* * * * *
 *
 * UNITED STATES *
 * DEPARTMENT OF THE INTERIOR *
 * BUREAU OF RECLAMATION *
 *
 * - - - *
 * HYDRAULIC LABORATORY REPORT NO. 32 *
 *
 * - - - *
 * MODEL STUDIES OF DOS BOCAS DAM SPILLWAY *
 *
 * BY *
 * J. E. WARNOCK and J. H. DOUMA *
 *
 * - - - *
 * Denver, Colorado *
 *
 * February 28, 1938 *
 *
 * * * * *

Guayama, Puerto Rico
November 20, 1937.

Reference is made to your letter of November 20, 1937, and office letter of November 30, 1937, concerning model studies of the Dos Bocas Dam spillway.

ABUTMENT ENTRANCE
DOS BOCAS DAM SPILLWAY

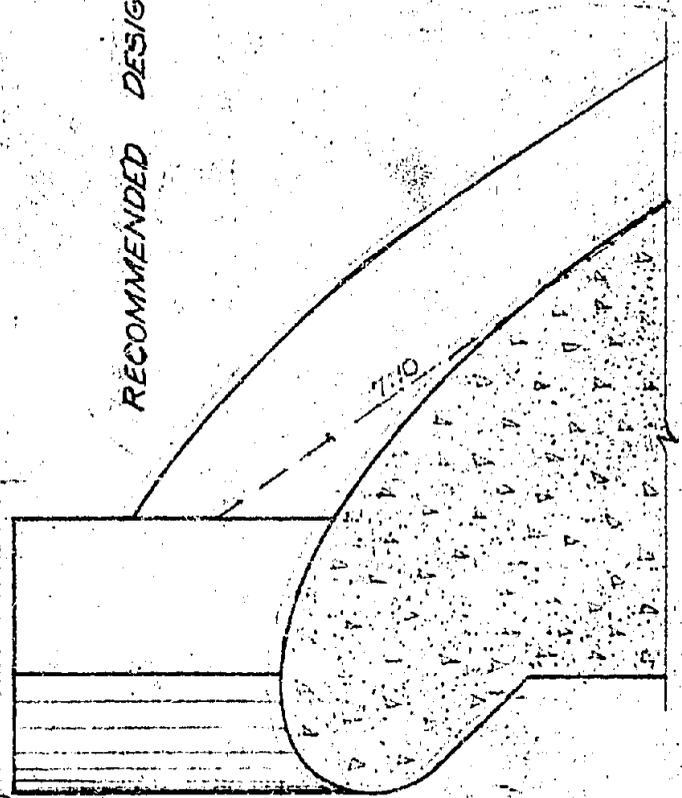
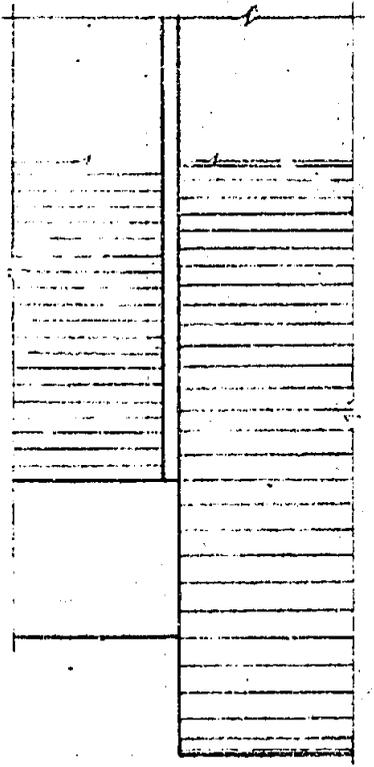
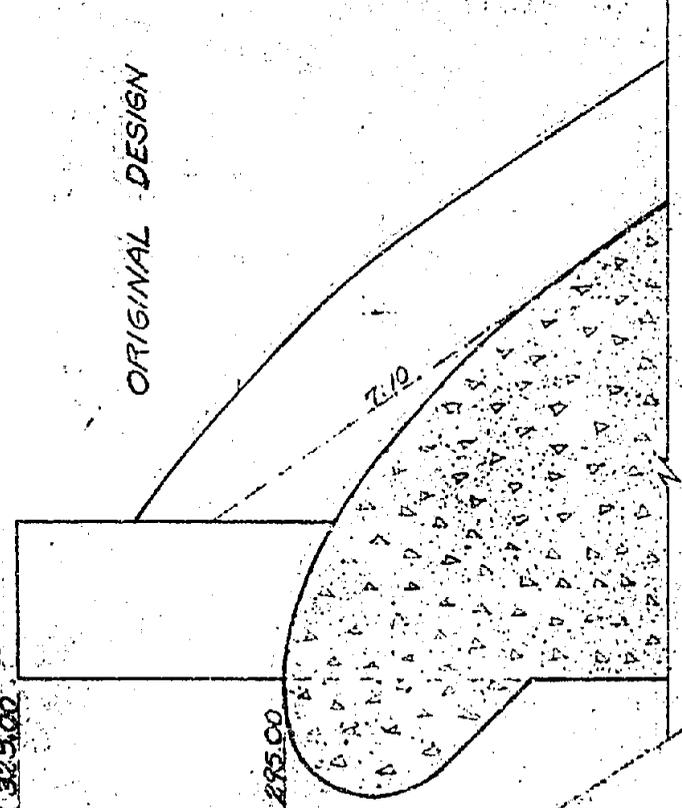
Abutment entrance. Operation with the original abutment entrance design was very unsatisfactory. The right-angle entrances caused the sheet of water to spring free from the spillway sides, resulting in a much reduced flow at the side-walls and an unbalanced flow condition in the stilling pool. The flow down the spillway was concentrated in the center, causing severe whirls to form on each side. These whirls cause disruption of the formation of the hydraulic jump. A new abutment entrance, shown as recommended design in drawing No. 2, completely eliminated this undesirable condition. Plates 3A and 3B show the original and recommended abutment entrance design. Plate 3C shows the sheet of water springing clear of the side-wall and plate 3D shows it remaining in contact with the side-wall. A smooth entrance

1. Abutment entrances. The right-angle abutment entrances caused the sheet of water to spring free from the spillway sides, resulting in a much reduced flow at the side-walls and the formation of severe whirls on each side of the stilling basin. The recommended design on drawing No. 2 improved the flow conditions.
2. Bridge piers. The original square-ended upstream pier noses resulted in a rough water surface immediately in front of the

BRIDGE PIERS
DOS BOCAS DAM
SCALE 1"=20'

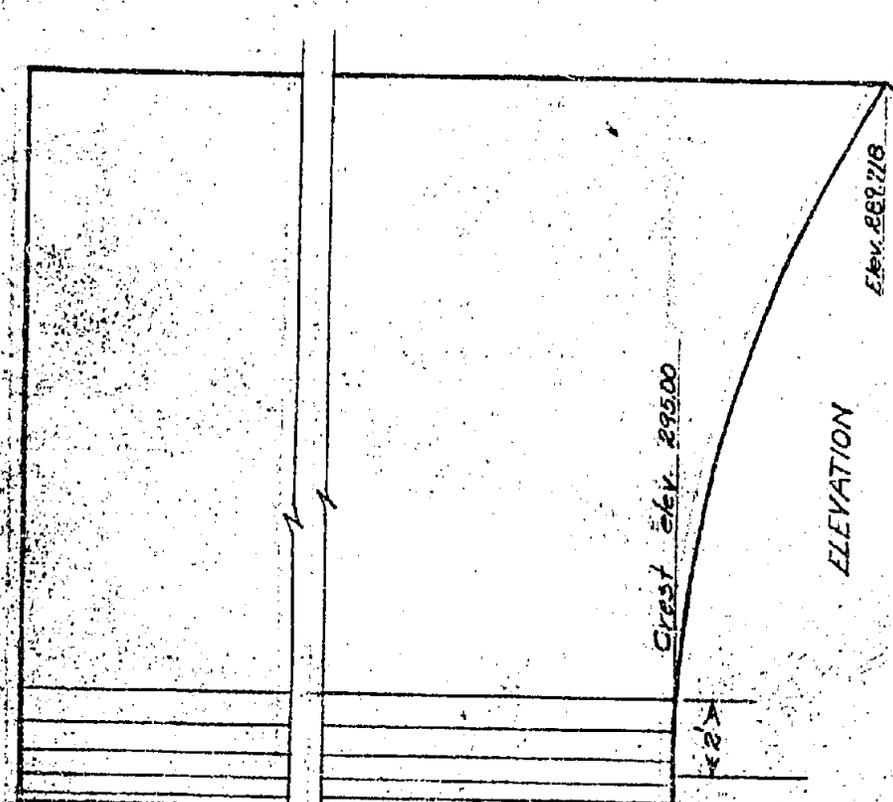
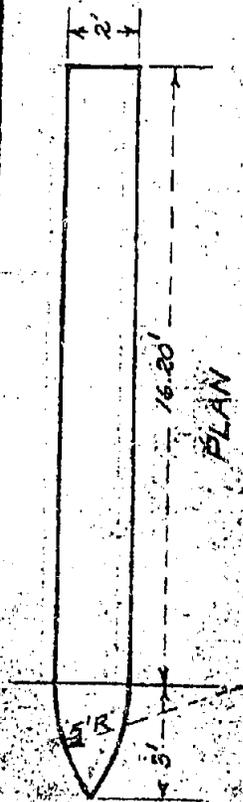
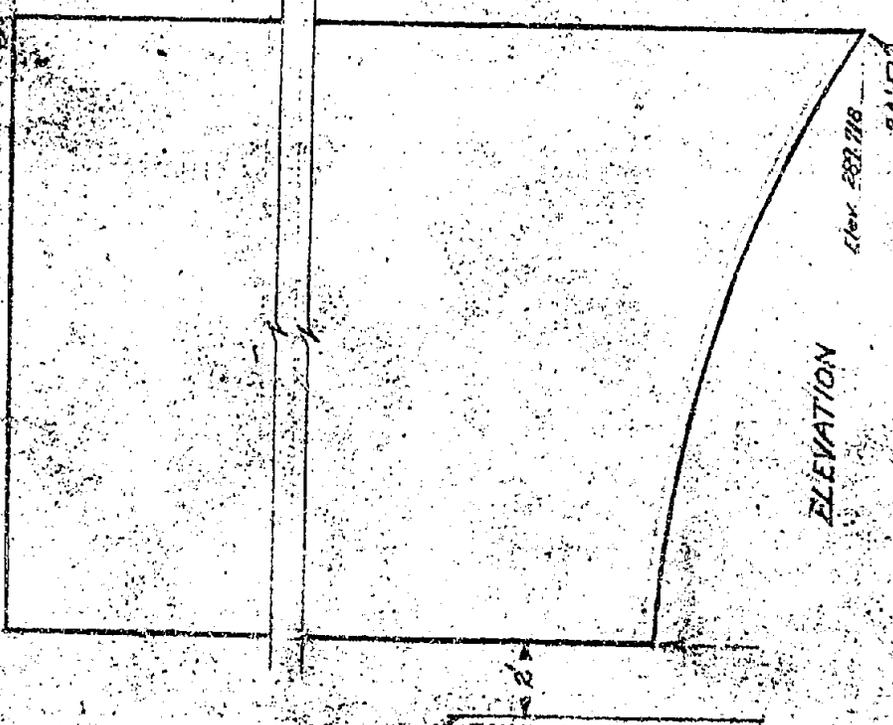
Bridge piers. The design of the upstream end of the original bridge piers (plate 3A) was unsatisfactory, as can be seen by studying plate 3C. The square-end upstream edges caused water to rise against the front of the pier to a height of four feet (prototype) above the normal water surface. Due to the square corners, the sheet of water periodically sprang free from the sides of the piers. If this action would occur in the prototype, resulting vibration might damage the bridge. The recommended bridge pier design is shown on drawing No. 4 and in plate 3B. This design proved entirely satisfactory since the water remained in contact with the side-walls at all times. Since there are to be no gates on this structure, a square edge at the downstream end of the bridge pier is hydraulically satisfactory so no change is suggested.

piers and aerated areas on the sides of the piers. The type of pier nose shown in drawing No. 4 and used on the upstream end gave satisfactory conditions.
